# **ADDENDUM for ENVIRONMENTAL IMPACT ASSESSMENT**

**A PROPOSED RESIDENTIAL DEVELOPMENT –  
PART OF AMBASSADOR HEIGHTS, ST. ANDREW**

2009 April 20

## **Appendix II - Study Rationale & NEPA'S Environmental Permit & Licence Applications Process**

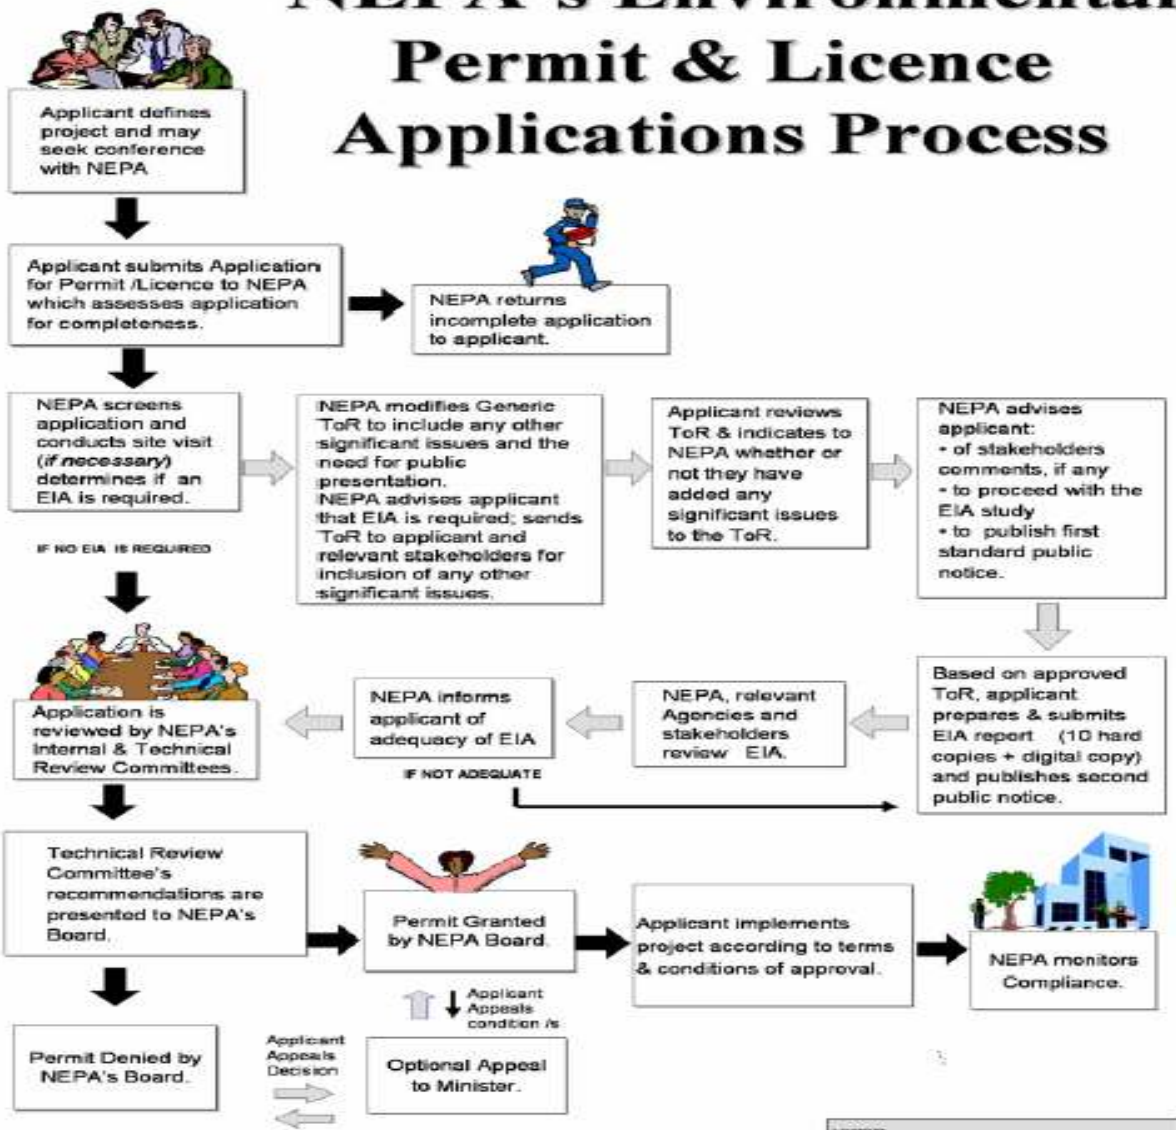
- 9) **Page XVIII: Study Rationale**

The purpose of this section is unclear. The title would indicate a rationale for why the study, i.e. the EIA is necessary. This, however, was not presented. This section should either be rewritten to present the rationale for the study or removed. The associated Figure 1 would also become redundant. If this is to be kept, it is recommended for the Appendix.

**Response:** The Study Rationale outlines the objectives of the EIA which includes “*provides information required to analyze the significant socio-economic and environmental effects of the Proposed Action and determines whether a permit would be granted*” It is to be included among the Appendices ( Appendix II)

Appendix V- Active Faults within Jamaica

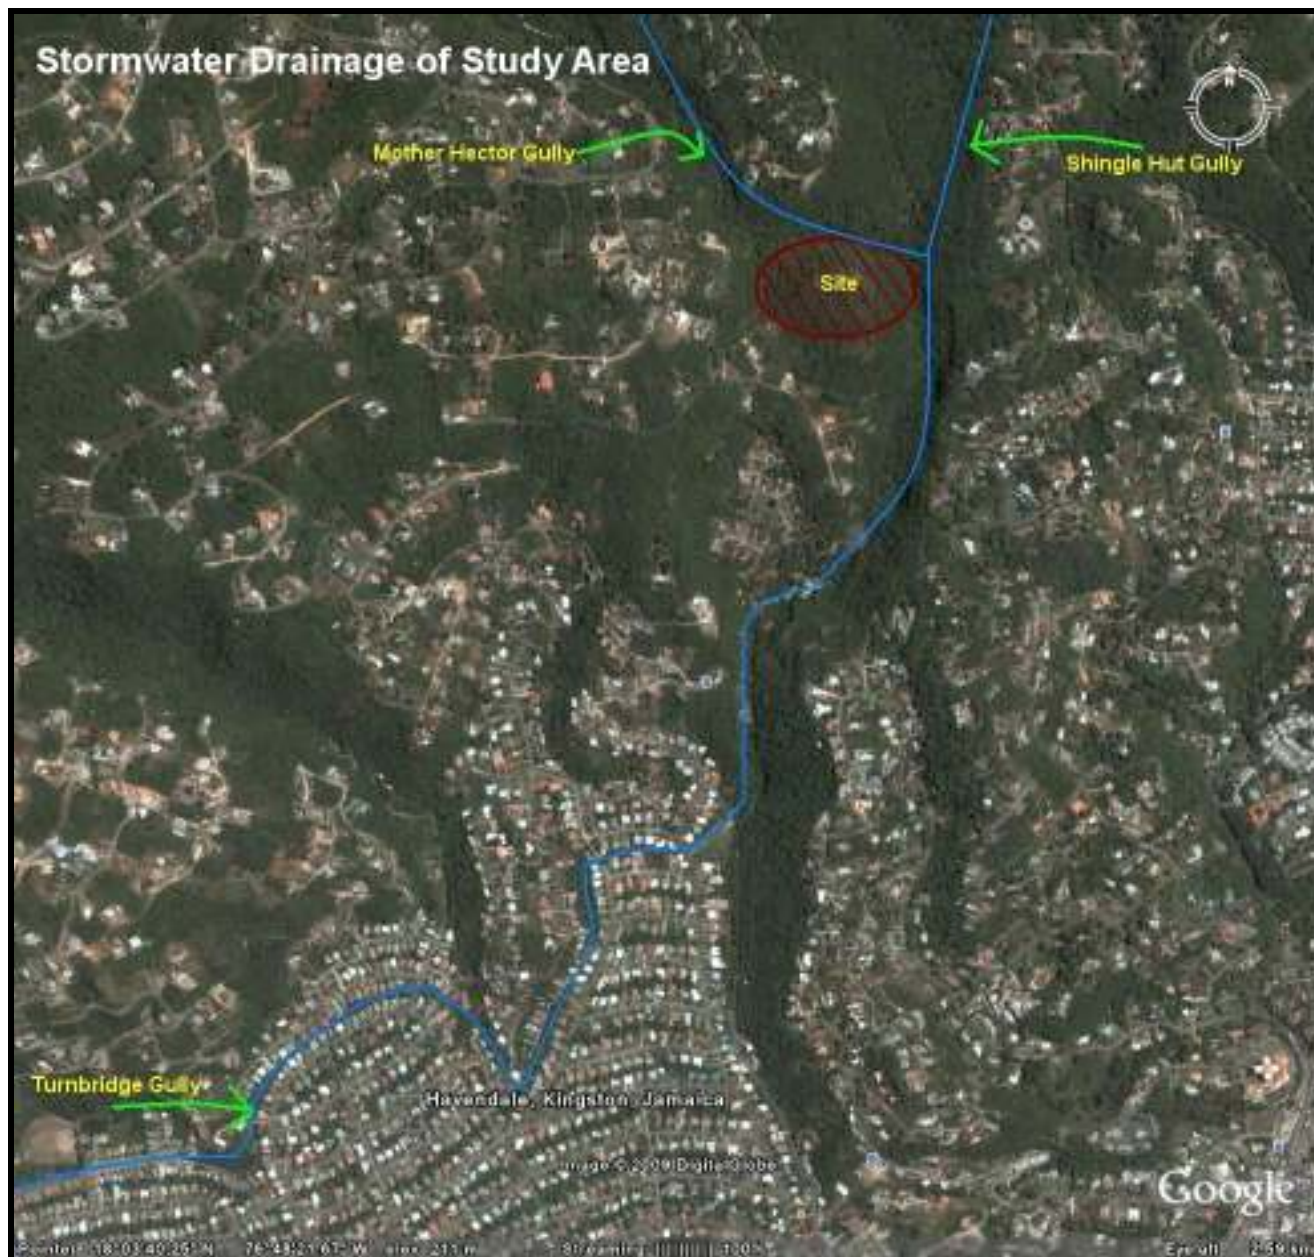
This section makes mention of the site being located between two inactive faults. An indication needs to be given as to how this conclusion was derived and its relevance to the “No Action” alternative. There is no historical evidence available to prove that the faults have been otherwise than inactive.

**Response:** The project area is hinged between two geological faults and is therefore influenced by these geological structures. These faults are not known to be seismically active and therefore slip motion/movement on the fault planes is not anticipated. Shepherd et al (1999) and the Kingston Seismic Hazard Assessment Project (1999) under the Caribbean Disaster Mitigation Programme (CDMP) have produced seismic maps for Jamaica and Kingston Metropolitan Area respectively. These are the most current seismic hazard studies done for Jamaica and have given estimated horizontal ground accelerations of 0.27 g and 0.3 g respectively for the project area with a 10 percent probability of exceedence in 50 years. This corresponds to a return period of 475 years.

There is no historical evidence to prove or disprove inactivity within Jamaica. There is a map, however, to show active faults, from which a fault's inactivity can be determined. This map was also prepared under the Kingston Seismic Hazard Assessment Project, see Appendix V. From the map it can be seen that there are no active faults within the Mannings Hill area.
